**Re: Arizona Department of Environmental Quality 401 Certification for Rosemont  
Copper, Public Notice 27-14AZ LTF 55425**

# **Impacts of the Rosemont Mine on Hydrology and Threatened and Endangered Species of the Cienega Creek Natural Preserve**

Brian Powell<sup>1</sup>, Lynn Orchard<sup>2</sup>, Julia Fonseca<sup>1</sup>, and Frank Postillion<sup>2</sup>  
July 14, 2014

**Figure 3. Relationship between length of flow of Cienega Creek at the Cienega Creek Natural Preserve and depth to water at the Cienega Well. The linear model (red line) explains 84% of the variation in the data.**

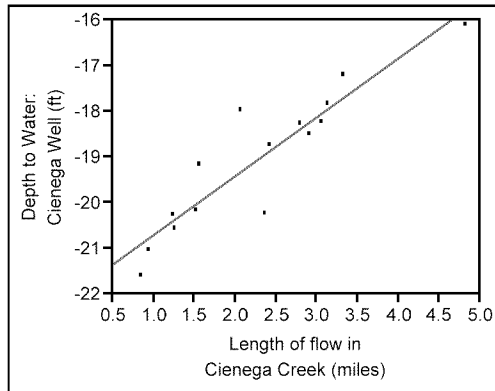
It is important to note that the Cienega Well was used in the report by Westland (2012; page 5), but they claim that their model of depth to water and quarterly flow length showed an unusual statistical distribution and therefore use of that well was discounted in favor of data from the Jungle well. The June length of flow data in relation to the Cienega Well do not show this issue (Figure 4) and the Cienega Well is certainly useful for estimating loss of streamflow length.

It is critical to note that the results between the modeling results by Westland (2012) and those reported here are significantly different. Using data from the Jungle Well, Westland (2012) found that with a 0.1 foot decline in depth to water there would be 176 foot reduction in flow length; just 41% of our results. They also did not model a scenario that may result from a mine impact that is greater than other projections but may be within the realm of possibility (i.e., a 0.25 foot reduction in depth to water).

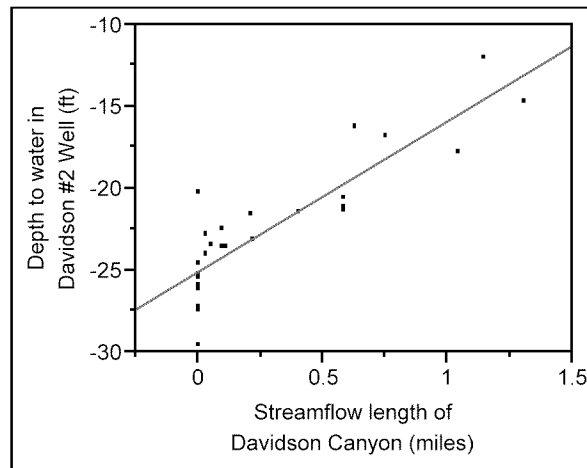
Tetra Tech (2010a) suggests that this reach of Davidson Canyon is not connected to the regional groundwater system, and that streamflow impacts due to drawdown of the regional aquifer therefore are unlikely to occur. Yet the results of our analysis (Figure 5) provide very convincing evidence that contradicts this position.

Figure 6. Tetra Tech's (2010a) Figure 5, amended to show actual channel bed elevation at the location. Red line shows position of the 2008 and 2011 channel bed based on LiDAR data.

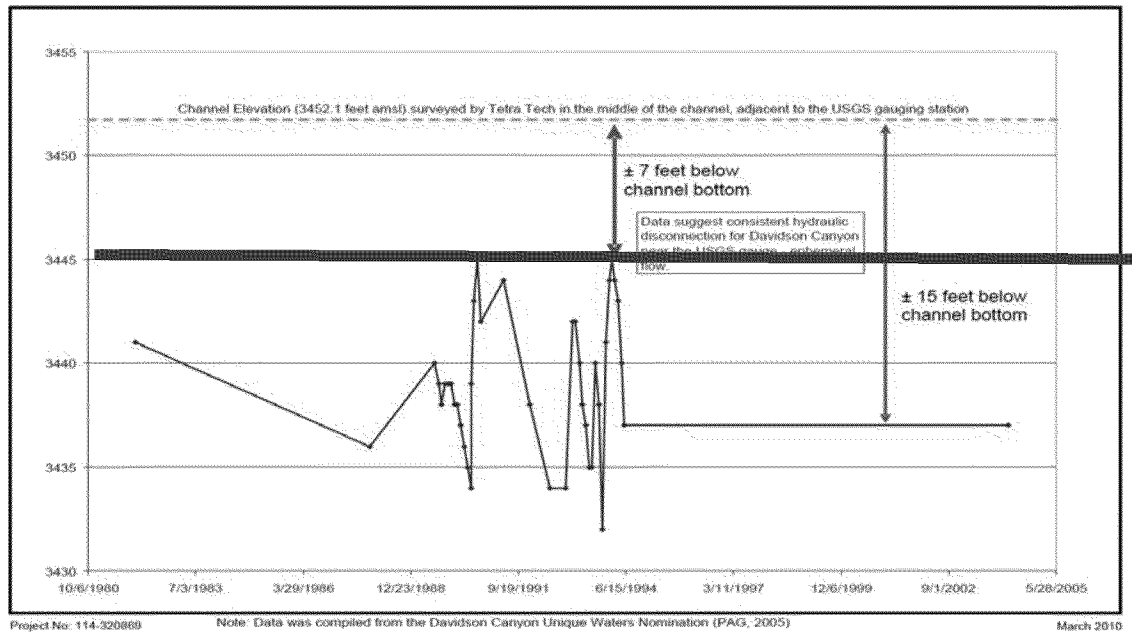
We also take issue with Tetra Tech (2010a) data. Underpinning Tetra Tech's assertion is an illustration and a channel bed measurement at the Davidson Canyon stream gage (Figure 6). The accuracy of this figure relies on a "mid-channel bed" measurement taken by Tetra Tech (2010a). We examined Pima County LiDAR-generated elevation data at the same location and found that Tetra Tech's "mid-channel" bed elevation is five feet higher than the channel bed in 2008. We then examined 2011 LiDAR bed-elevations at the same location, which rule out the possibility that five feet of aggradation occurred, as would be required by Tetra Tech channel bed measurement. Instead, the actual bed elevations in 2008 and 2011 vary by less than 0.6 feet (Figure 7). Thus, the actual channel-bed is within a foot or two of the water table as measured in Davidson #2 Well.

The water-level measurements presented by Tetra Tech came from the Outstanding Waters nomination submitted by Pima Association of Governments (2005), which identified this reach as intermittent. Tetra Tech (2010a) uses the same data to infer that this portion of the channel is ephemeral. It is unreasonable to assume that groundwater never could discharge to the surface, or that it has been persistently below the bed between 1994 and 2004, as is indicated by Tetra Tech with the horizontal line connecting the last two groundwater measurements (Figure 6). It is even more unreasonable to extend that inference to the entire upstream reach, as is done by Tetra Tech (2010a).
